29 April 2020

Application number: SSD-9483

### **Letter of objection to the proposed development of Chatswood Public School (CPS)**

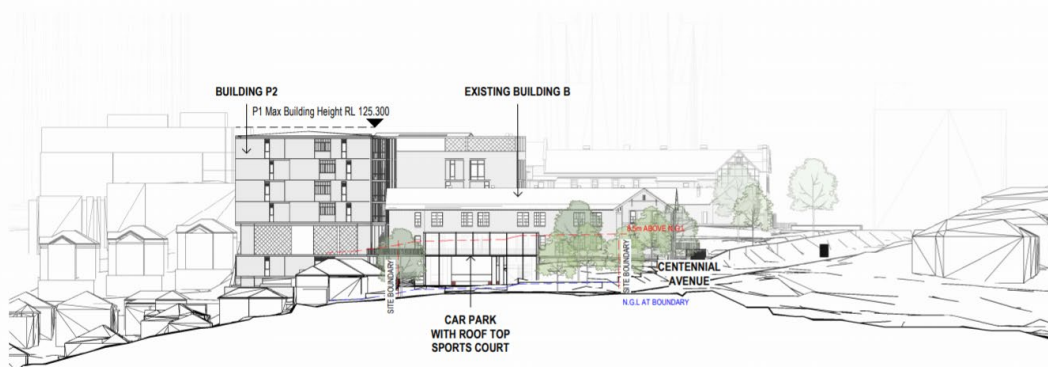
As such, the entire site is classified as ‘Heritage’ (SEARs request p. 5). The current proposal, however, has declared only Buildings A and B are considered worthy of heritage. The ‘Lowers’ retaining wall is specifically identified as a heritage item (EIS) but this will be covered by the construction. We would like an explanation of how the planning committee can pick and choose which aspects of the site they consider worthy of heritage.

We would also like justification of how the following view will be retained, noting that we do not consider it reasonable to say that windows on the east side of P1 and very limited windows on the west side will retain this view. Furthermore, please explain how the obstruction of these view will not impact on heritage of the site

3 Jenkins Street - Street Elevation  
SCALE: 1:500

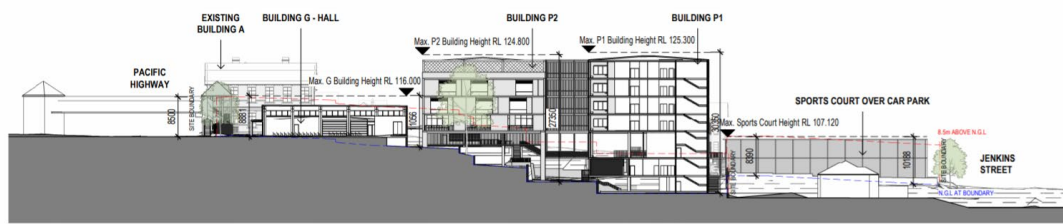
While this may be true of the eastern side this is not at all true of the western side. As is obvious from the Jenkins Street – Street Elevation, building P1 appears almost double the height of Building B and the mass, scale and visual bulk of P1 dwarfs this heritage building. There is no capacity for planting given the proximity of the planned building to the boundary and furthermore, no tree grows to six/seven storeys in height. We would like an explanation as to why the view from the Western side of the highway, as per Jenkins Street – Street Elevation, has not been considered.

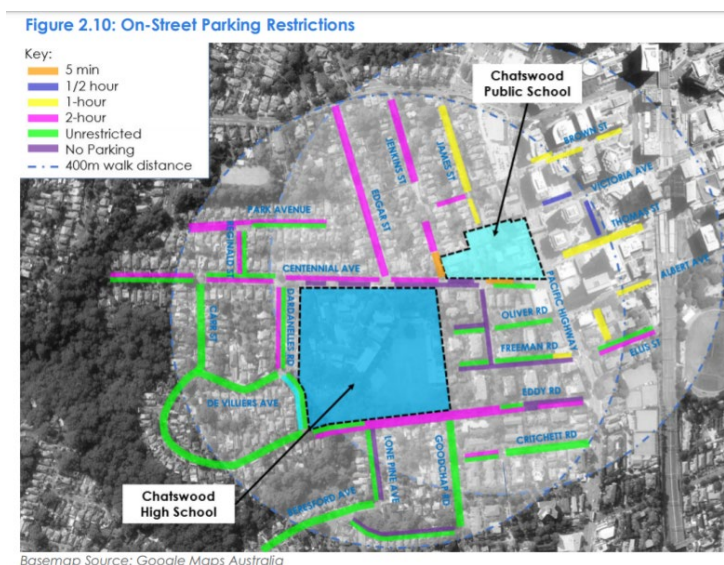
Alarminglly, the proposal will result in the removal of 62 trees. This has not been justified in the documents provided and has the potential to contribute to urban heat, reduce amenity and impact on the leafy

character of Chatswood. Please provide a list of the trees that will be removed and the plans to replace these in addition to a justification for the removal of these trees

**Figure 2.11: Jenkins Street-Centennial Avenue Intersection – Morning Peak Hour**

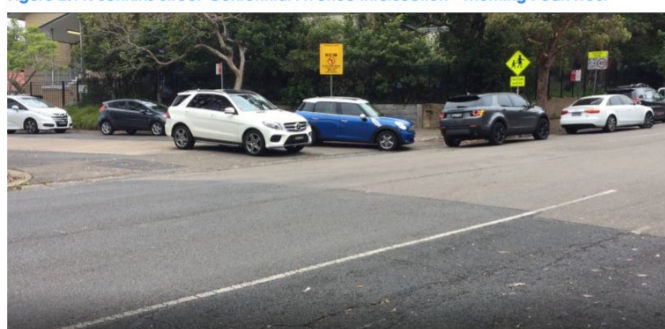
Secondly, the traffic report misrepresents the bottleneck at Jenkins Street and Centennial Avenue, extending to Centennial Avenue and the Pacific Highway. The photo below is an absolute misrepresentation of the usual morning traffic. It appears that the photo was taken when the school was closed – there are certainly no students to be seen which would be the regular case when picking up or dropping off. On a regular school day traffic and pedestrian movement in the vicinity of both schools is chaotic and unsafe. There are usually two lanes of traffic queued on Centennial Avenue making an exit or entry to Jenkins Street almost impossible. The current proposal does not address these issues and has the potential to exacerbate the situation. Please provide an explanation as to why misleading photographs have been used and how this traffic will be managed to mitigate risk and queuing.

Figure 4.3: Existing Modal Split – Chatswood Public School Student

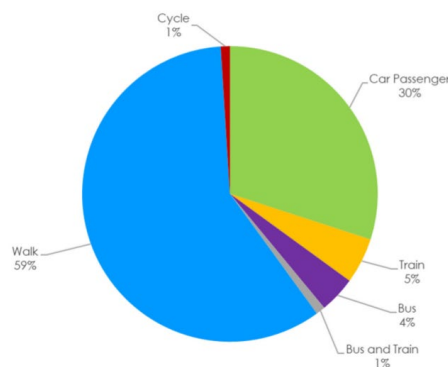
As evident in Figure 4.3, 40 percent of the CPS student body travel by car (30 percent), bus or train or and could be redirected to these schools reserving the CPS site for those within the immediate vicinity. We would like an explanation as to why these options above have not been used to accommodate the 54 percent increase in students since 2012. Similarly, why have the boundaries not been reduced?
